SEWAGE DISPOSAL SYSTEM

MARYLAND STATE DEPARTMENT OF HEALTH*

SUBDIVISION Indian Hill ROAD Howard Lodge Road LOT 12511

PERMIT CARD

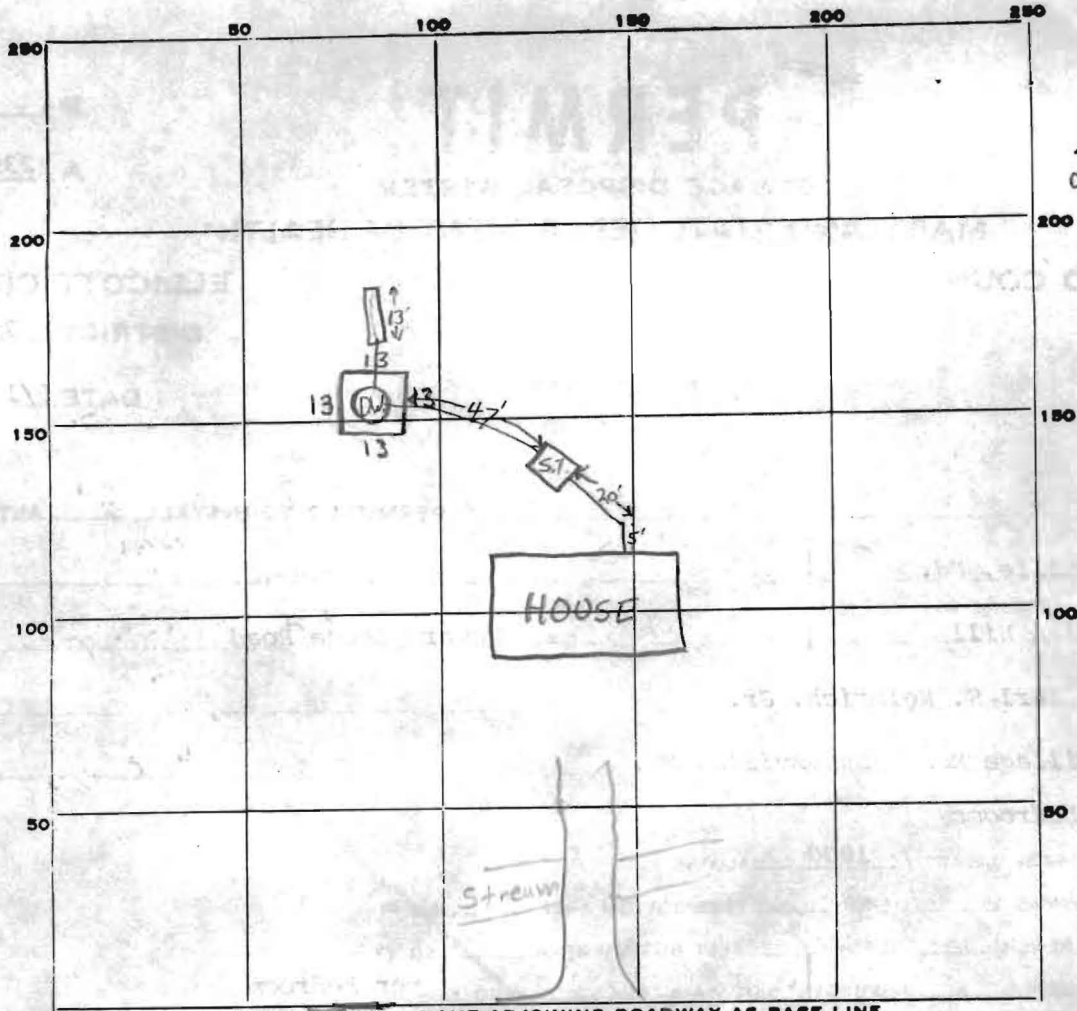
5/22/78 before
5/19/78 u.m. please
trench in f.m. if possible

REMARKS: 5/19/78 13' long trench c gravel from 3' → 10' still need trench checked this a.m. has caved in, new trench to be dug. O.K. to install 10' orange clay stoneware in trench to check depth F.S.
 5/22/78 O.K. to corral work F.S.

DATE SYSTEM APPROVED 5/22/78
